Subject: Digital Channel Banks - Modifications for D1D, D2, and D3 to increase carrier failure delay timing SL: IL 81-02-438

type letter: Information Letter

date: February 20, 1981

Reviews carrier failure alarm delay timing for digital terminal equipment, and provides ordering information for modifications to change most of the early channel banks to agree with current design. Application considerations are reviewed.

FIGURE 1

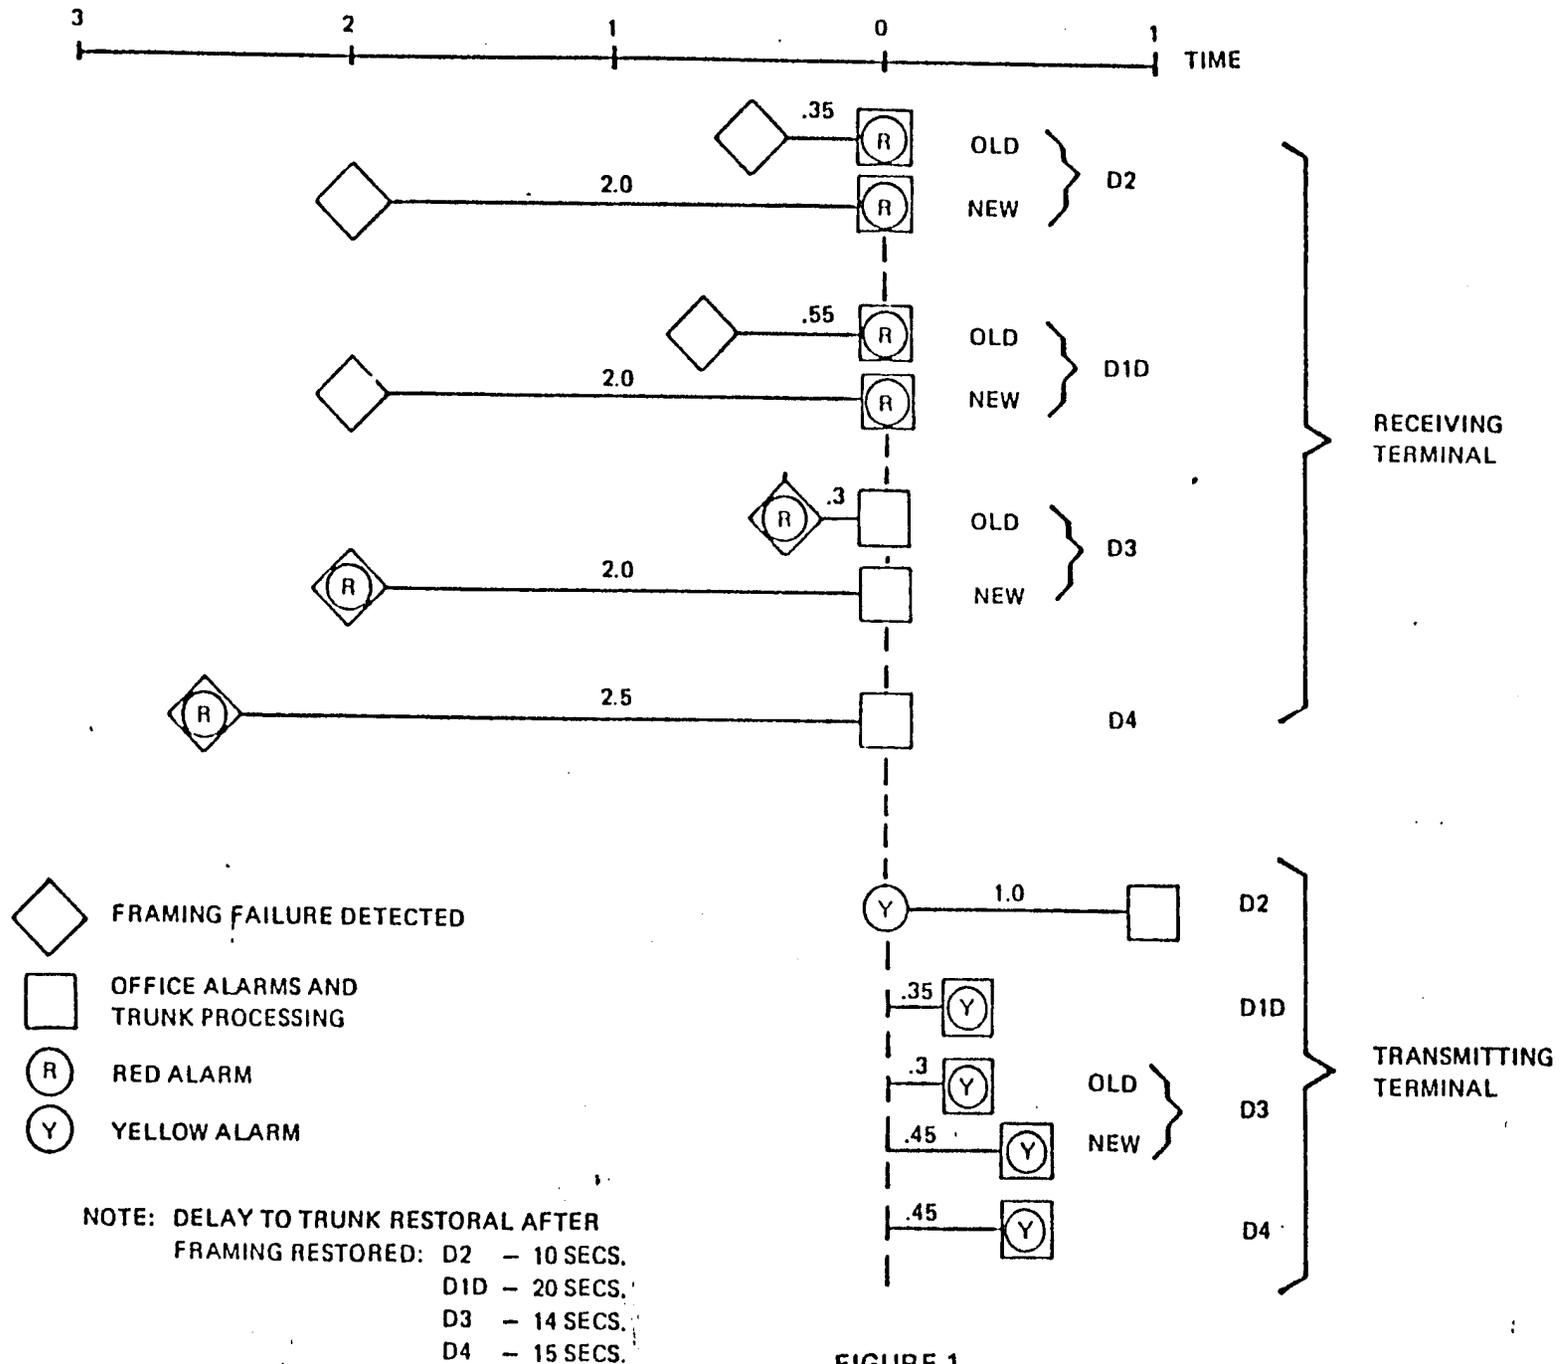
Figure 1 shows the timing sequence for all W.E. D3 compatible banks. On the Figure, time is normalized to the moment office alarms and trunk processing occur at the terminal that has lost framing.
